**ADDENDUM NO: 1**

**Req No: 76618 Fleet Management – Underground Lift Replacement**

# UNDERGROUND LIFT REPLACEMENT FOR THE CITY OF CHATTANOOGA FLEET SERVICES BUILDING

## ADDENDUM NUMBER 1

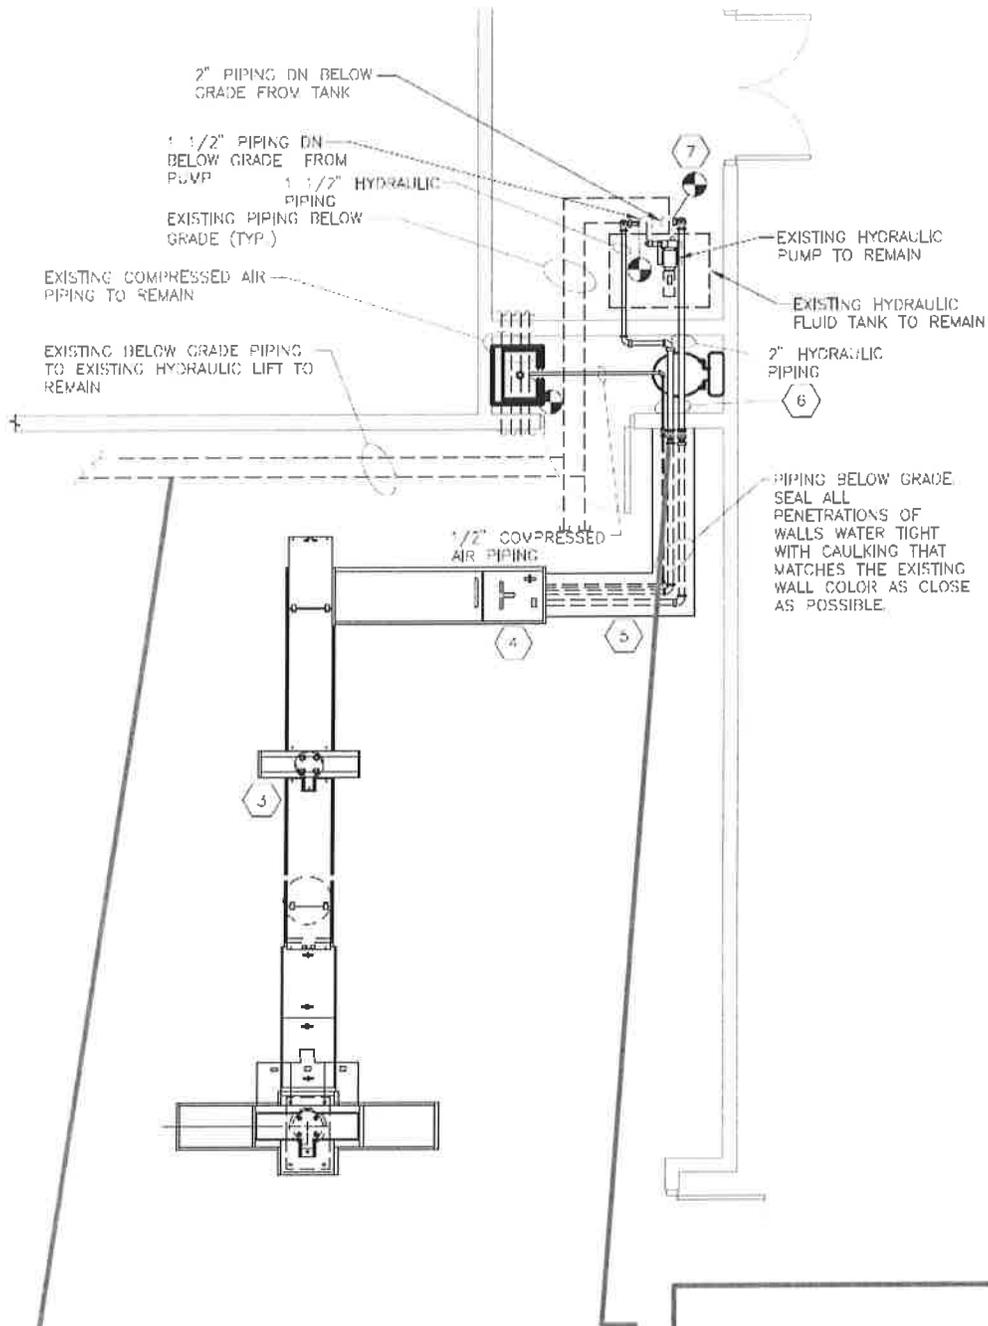
- Include within the bid as an Add/Alternate the costs required for replacing the piping to both lifts in its entirety. Abandon piping below grade as much as possible to minimize saw cuts and concrete replacement. The existing piping that is no longer to be used is to be abandoned below grade after being sealed liquid tight as described on the drawings or demolished as needed should it be in the way. Piping is to follow the routing included within the plans from the mechanical room to the lifts above the bathroom as shown on the plans. Size piping to accommodate both lifts. Piping to existing lift is to branch off of the main piping as the main piping drops below grade. Please see attached not to scale plan for reference. Field verify piping lengths as required. Existing lift controls are to remain as currently installed.

REPLACE EXISTING PIPING TO EXISTING LIFT TO REMAIN AS REQUIRED. WHERE FEASIBLE, ABANDON PIPING IN PLACE. DEMOLISH PIPING AS REQUIRED.

BELOW GRADE LOCATION OF PIPING BRANCH TO EXISTING LIFT
